**BREEDER REACTOR DEVELOPMENT
OPERATION**

RE: License No. DR-15
Docket No. 50-231

Proposed Change No. 2 to the SEFOR Technical Specifications was submitted to you on June 12, 1970. As a result of discussions with members of your staff, we have decided to modify certain portions of the Proposed Change.

SEFOR SAFETY
REVIEW COMMITTEE

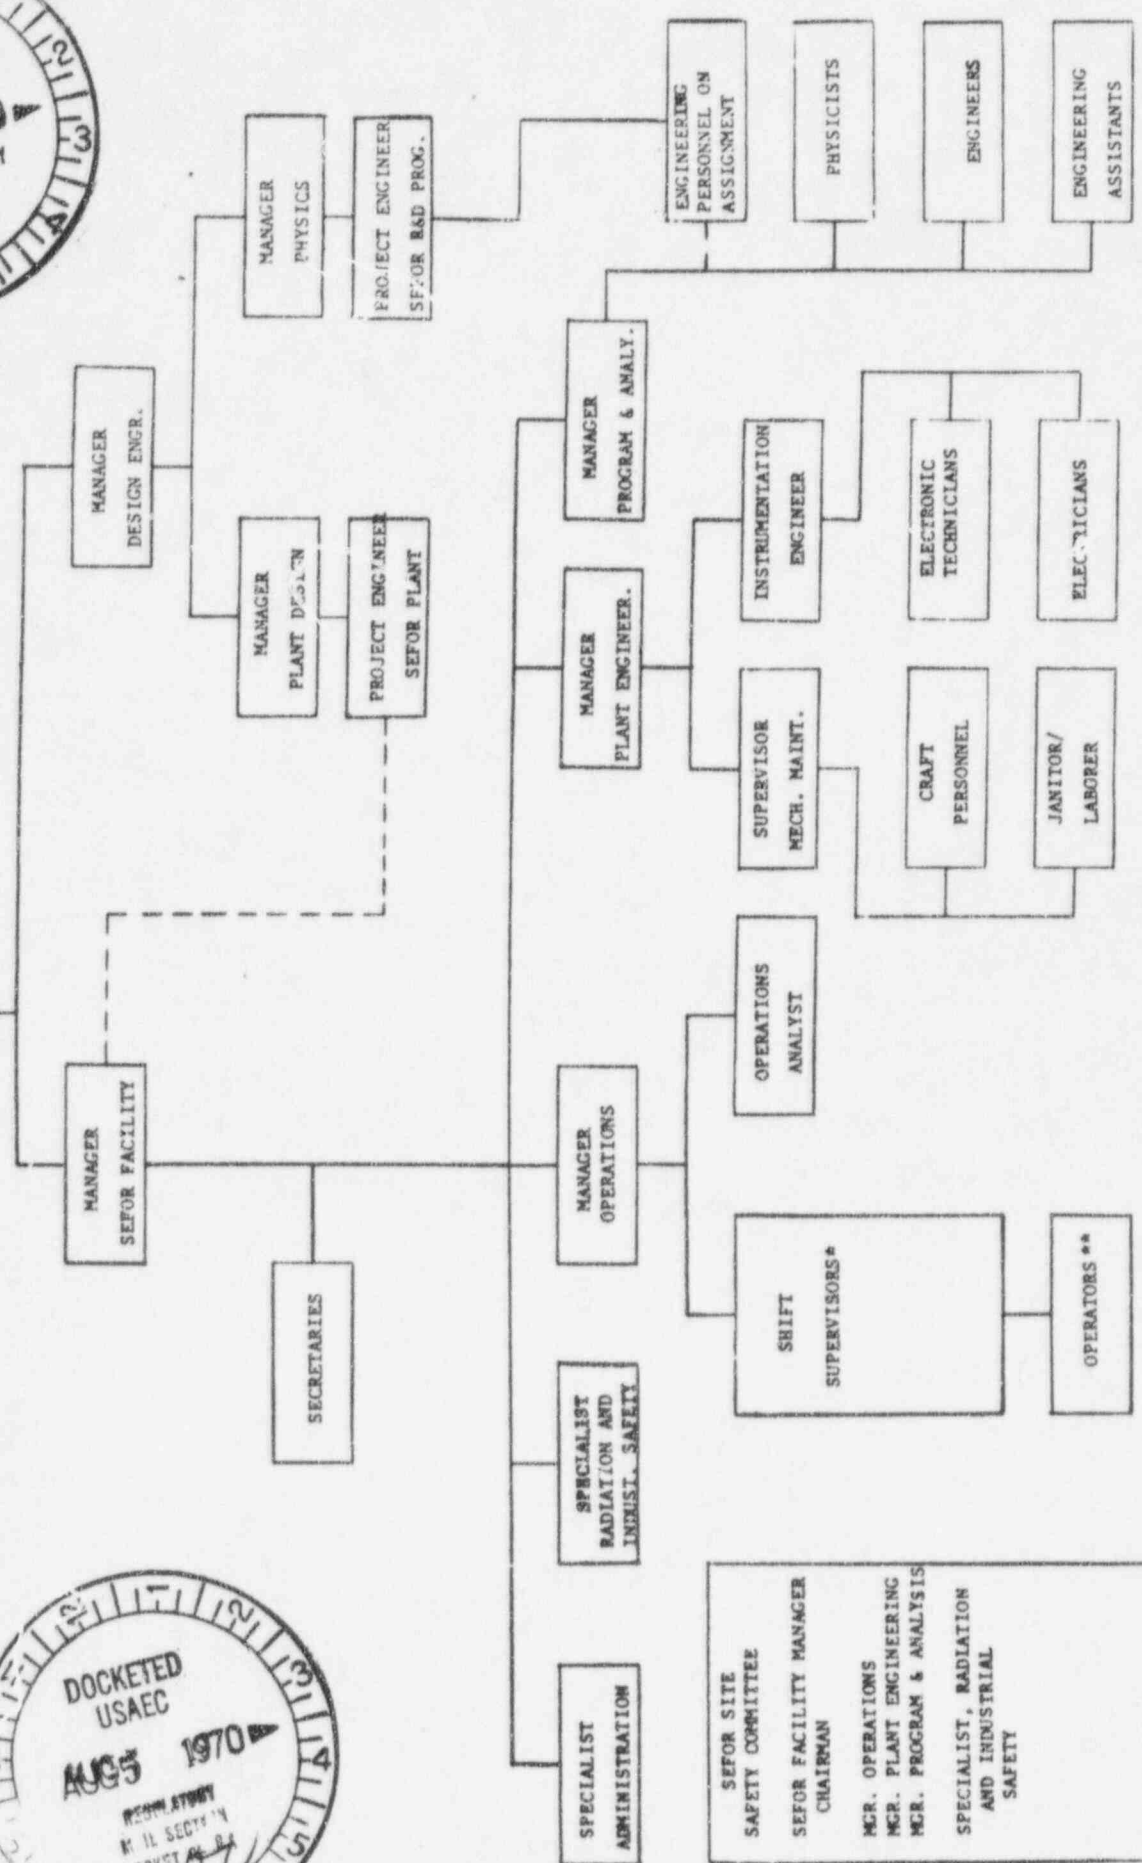
Enclosed are forty-three copies of pages 6.1-2 and 6.1-5 which have been modified and corrected. Please substitute the attached pages for the corresponding pages in Proposed Change No. 2.
